A tactile, dark poker theatre that opens to the real Vegas sunset. Management requirements enter as production constraints, not a replacement visual language.

WORKING VISUAL BASE / Guy skeleton correction

PROPERTY A PRIMARY / GLAZING RETAINED

Owner sources preserved. Review package only; no build, procurement or external release approval.

SUNSET

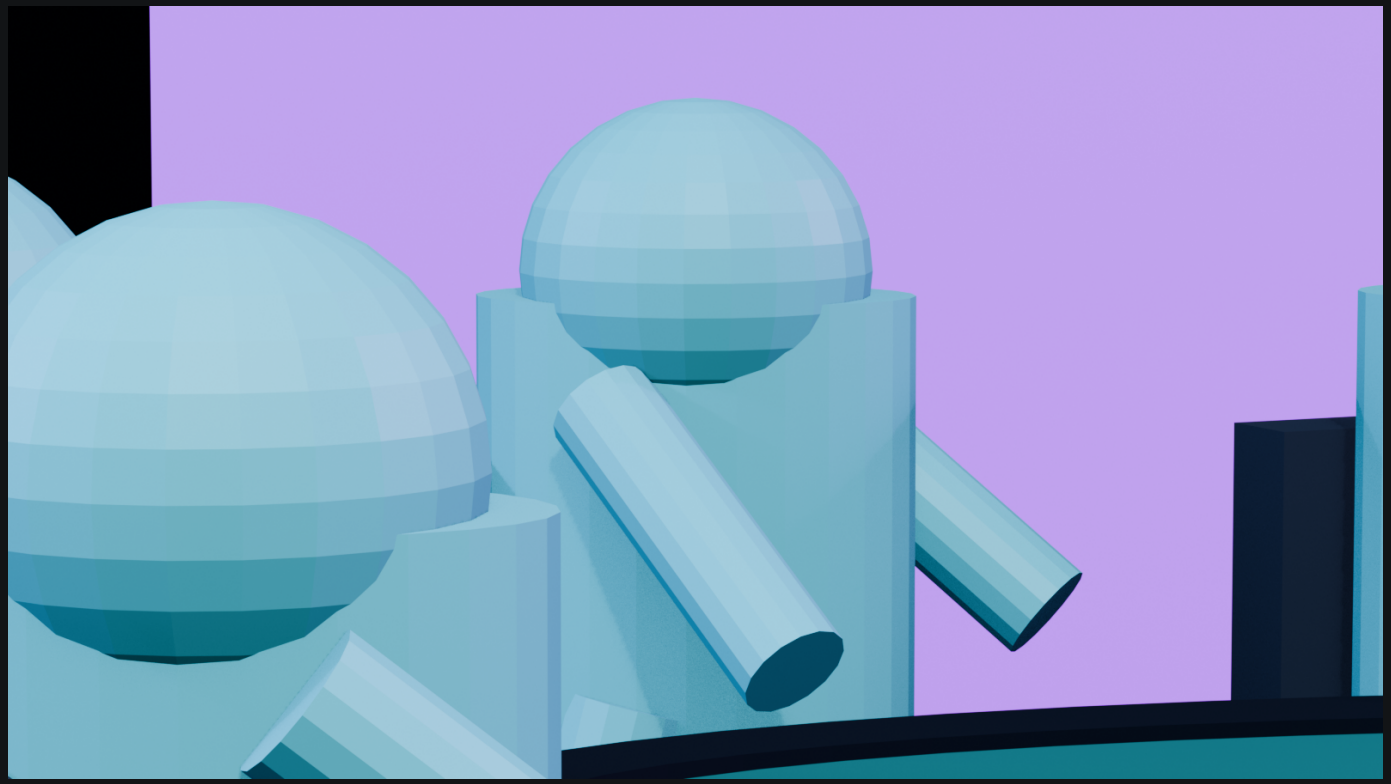
Let the sky carry the transition. The middle reference expresses timing only: its altered pool, landscaping and side walls are not adopted.

C1 > S3 / MODELED

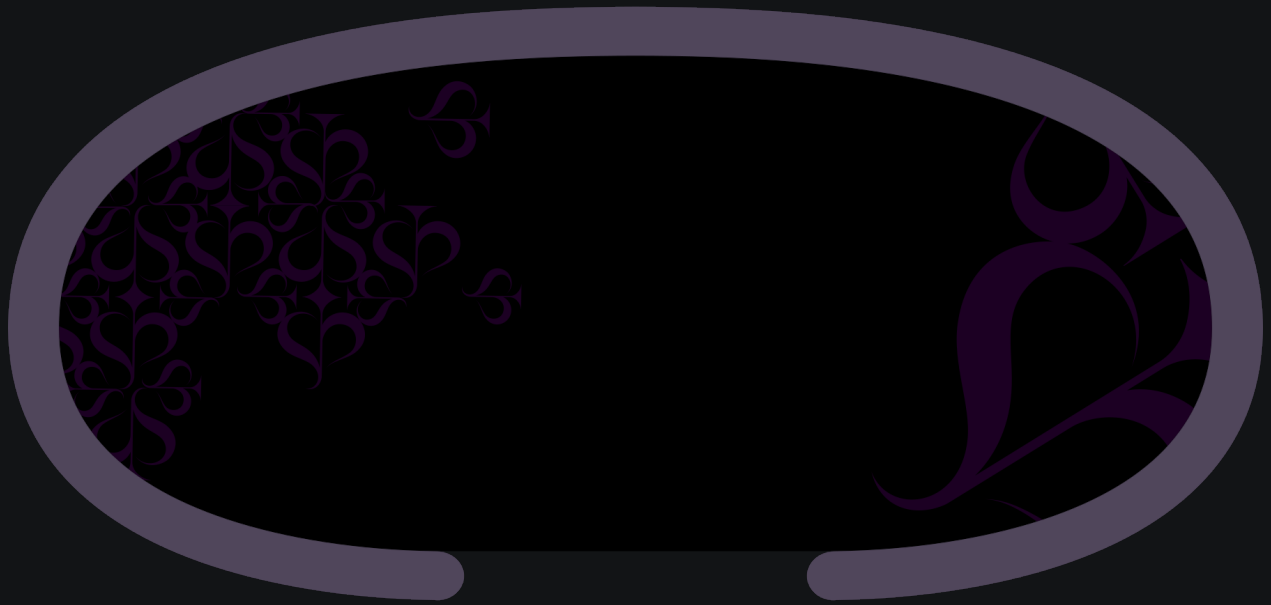
Lens Z 1.70 m above original slab; 1.50 m above the proposed 0.20 m stage. Frame at target: 1.40 x 0.7875 m. Aim Z 1.22 m.

This is a modest downward angle, not a verified seated-eye datum. Confirm the real chair, posture, lens and sensor crop in the occupied test.

V5 MANAGEMENT GEOMETRY

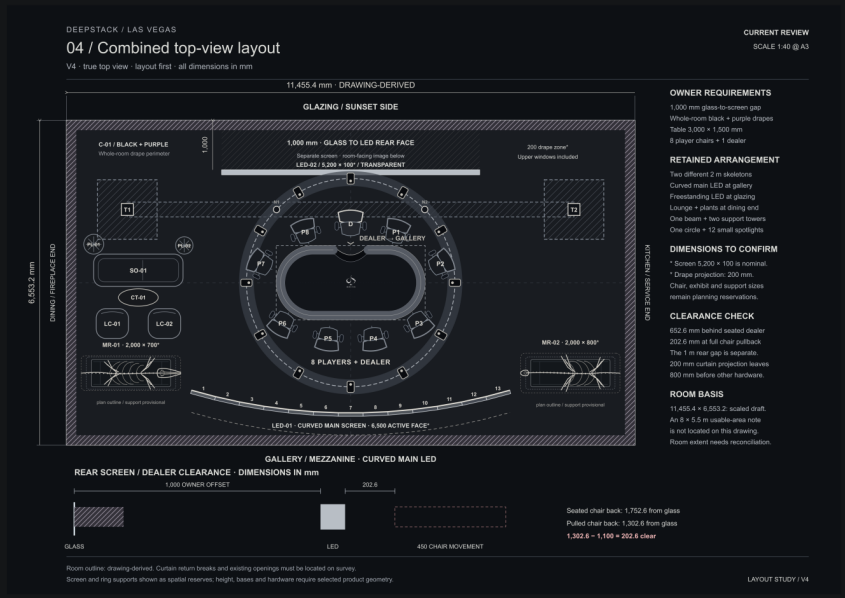
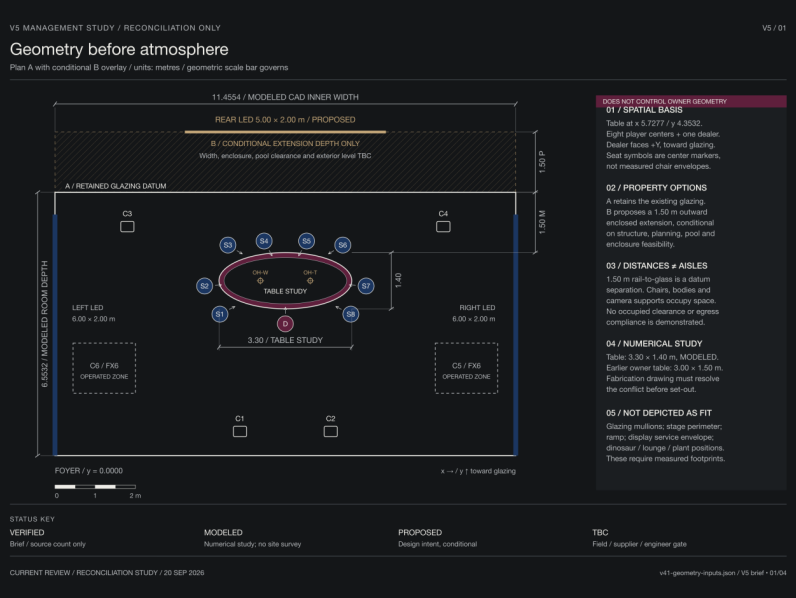
CONFLICT / DECISION GATE	OWNER RECORD	MANAGEMENT RECORD
Table envelope	3.00 × 1.50 m; source-derived scoop	3.30 × 1.40 m; ellipse study / vendor CAD TBC
LED arrangement	One curved gallery LED + rear transparent LED	Two flat 6 × 2 m side runs + 5 × 2 m rear allowance
Rear screen / glass	1.00 m room-side offset to screen rear face	1.50 m beyond glass to proposed rear LED plane
Rig architecture	One straight beam / two towers + true circle	Foyer tower(s) → balcony support → table overhang
Fixture / height basis	12 ring spots in V4; later 10-light note unresolved	Fixture distribution + all support heights need engineering
Skeletons / scenic objects	Two 2.00 m skeletons; supports / widths provisional	Skeleton, lounge and scenic locations are not modeled
Dealer / camera orientation	V4 window-side dealer; Guy master appears gallery-side	Dealer faces glazing; fixed camera lanes use that orientation

HOLD POINT Neither record is a construction set-out. Reconcile table, dealer, screen planes and rig before a new controlled plan.

E1 / REAR LED ELEVATION AT y = 8.0532

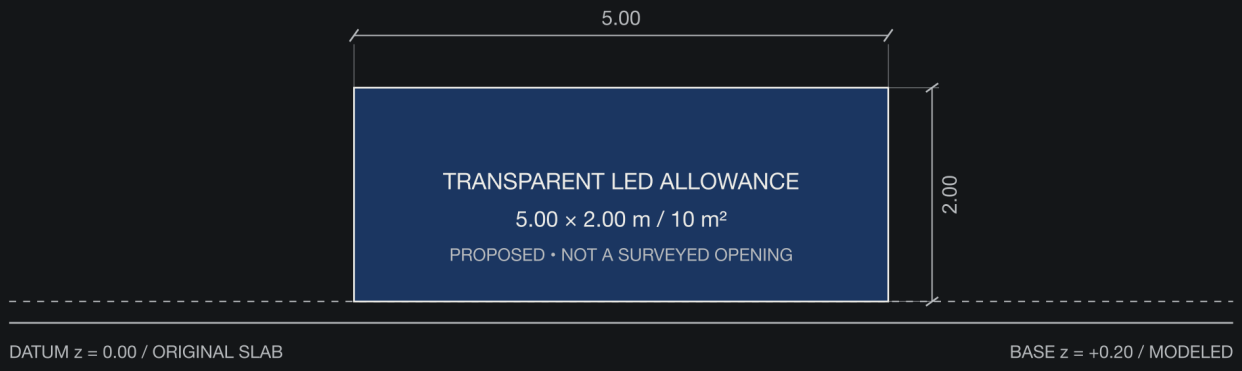
No guessed window height, mullions, facade perimeter or exterior slab.
The emitting allowance is independent of the actual clear opening and support frame.

Survey clear opening + mullions.
Verify support and service depth.
Test reflections, scan / shutter, brightness, cooling and power.
Fix enclosure + exterior datum.

R1 / FOYER → BALCONY → TABLE OVERHANG

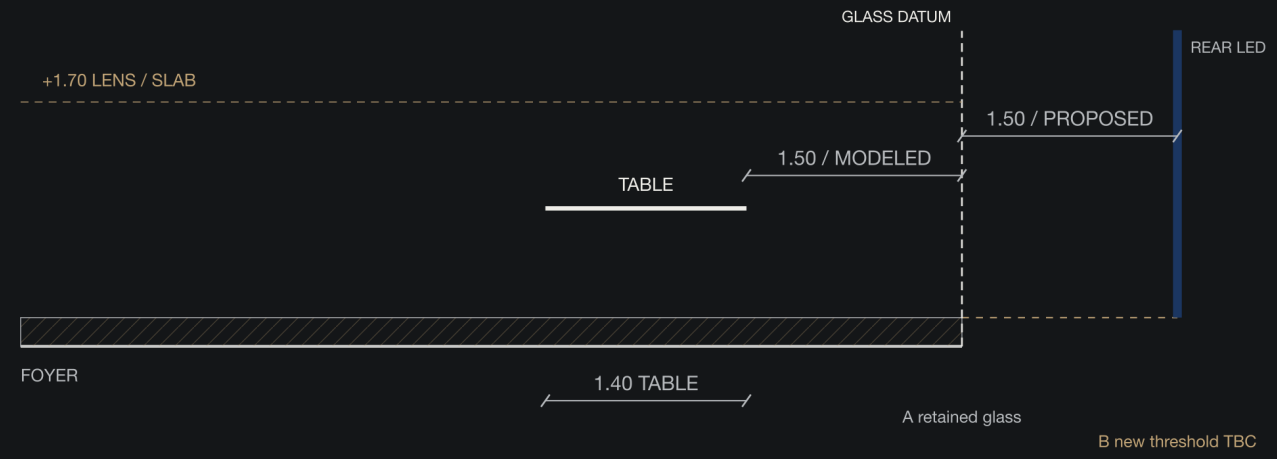
Upper diagram shows connection intent only. It provides no tower count, span, truss section, load, fixing or cantilever approval.

Survey existing structure.
Design tower footprint + ballast.
Check balcony reaction capacity.
Resolve attachment permissions.
Calculate total + dynamic loads.

S2 / LOWER LONGITUDINAL SECTION AT TABLE CENTRE

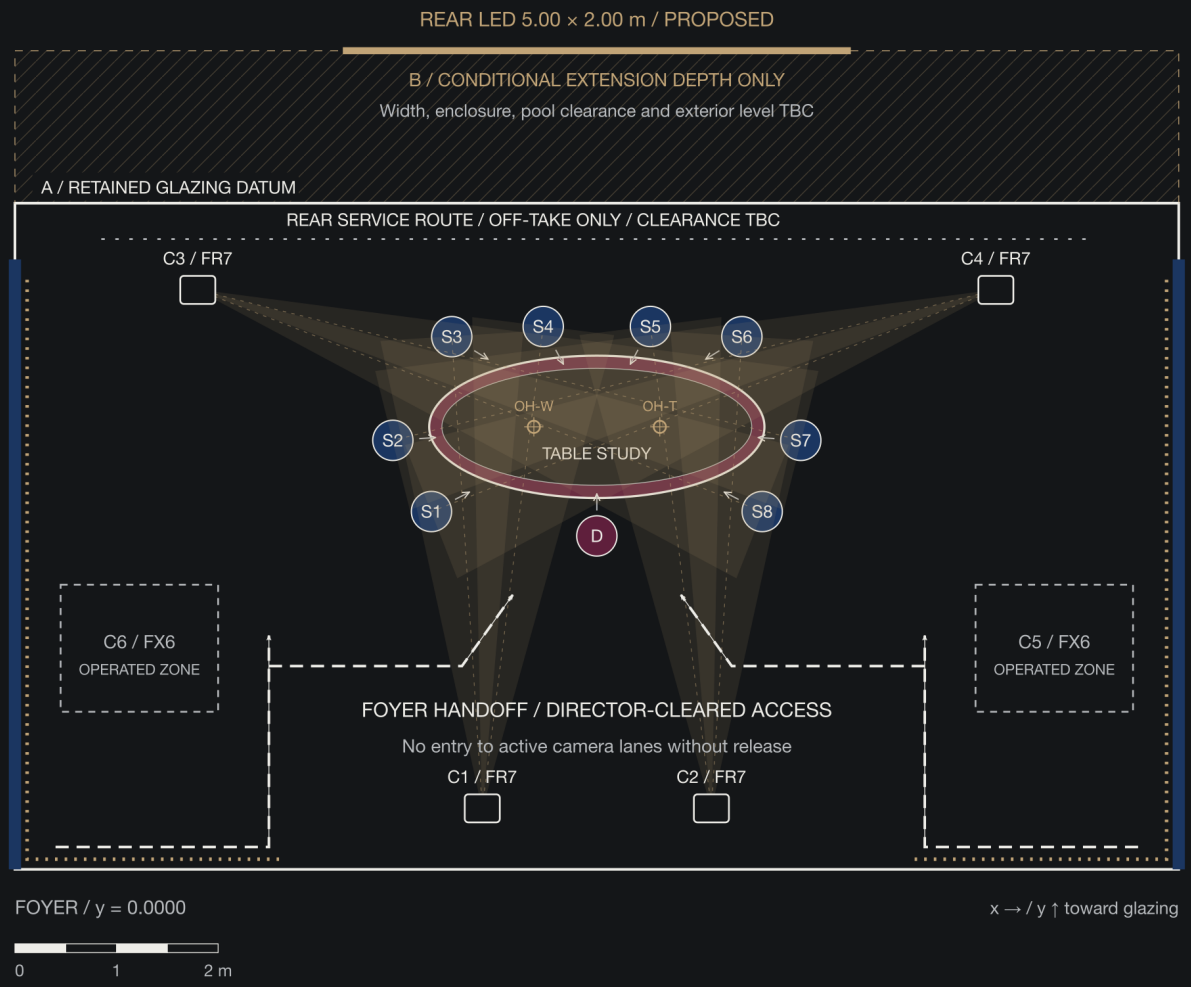
Lower geometry is MODELED at uniform metric scale. Upper rig is schematic and has no shared vertical scale. No fake ceiling dimension is introduced.

0.20 m rise requires a resolved access / ramp / edge design.
It is not an accessibility sign-off.

Crew circulation, cable strategy and camera lanes / spatial proposal, not clearance approval

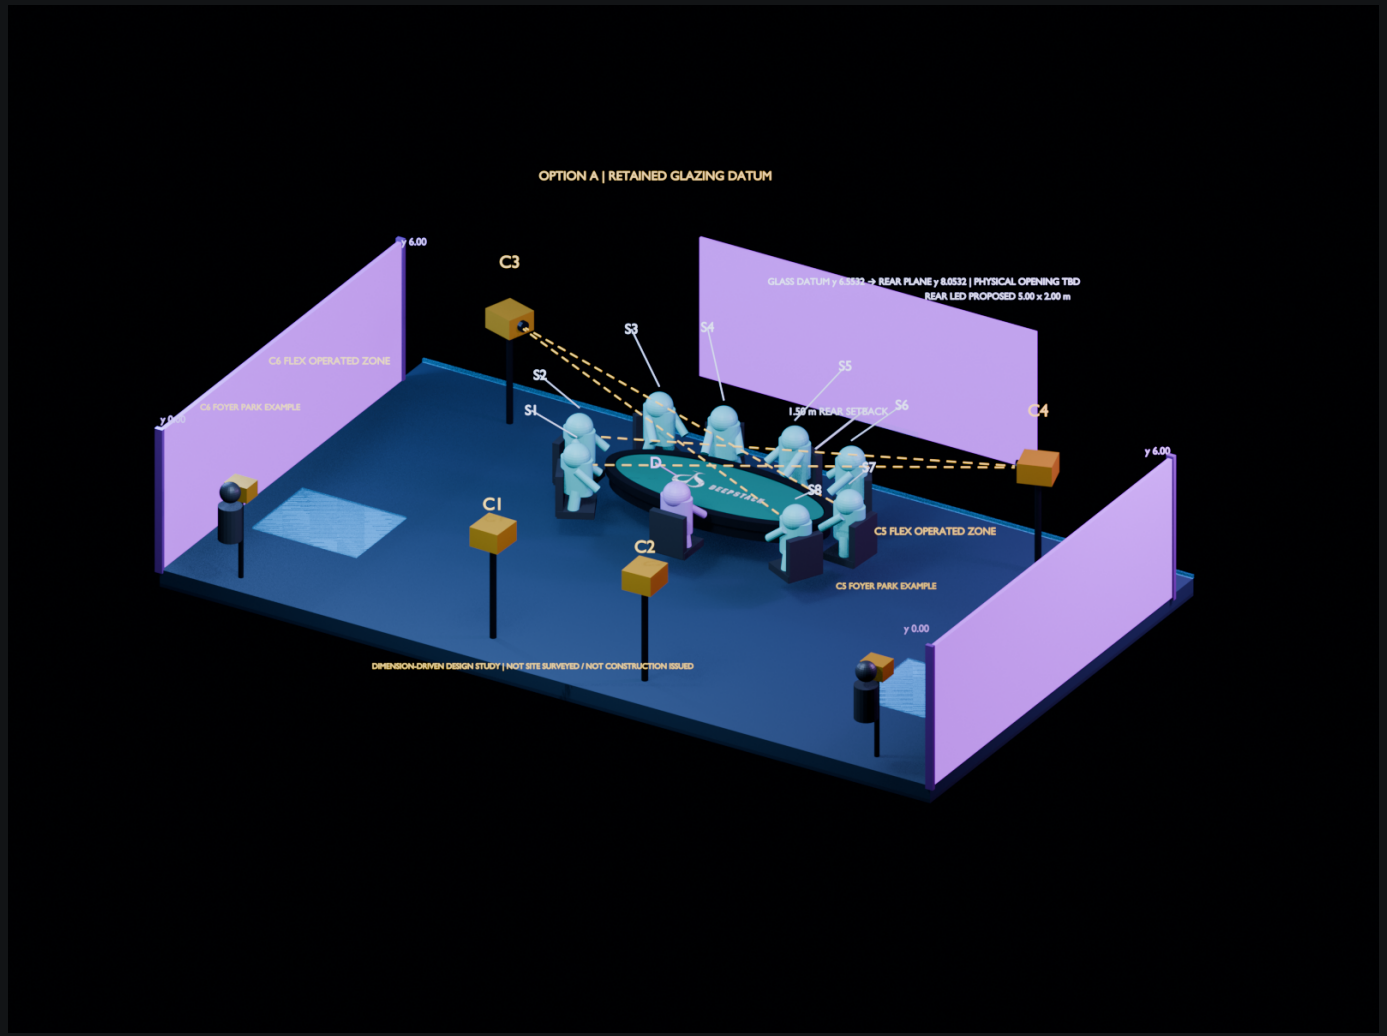
Amber wedges show modeled 1.40 m single-player target width. They are frame-study indicators, not complete 3D keep-out volumes.
C1→S3/S4 · C2→S5/S6
C3→S7/S8 · C4→S1/S2

White dashed: foyer-side access. Rear service only between takes. FX6 roaming requires director release from live frames. Route widths + turning envelopes TBC.

Dotted perimeter runs are intent. Separate power / data as required. Use protected crossings; resolve stage penetrations + strain relief. No load schedule or route fit yet.
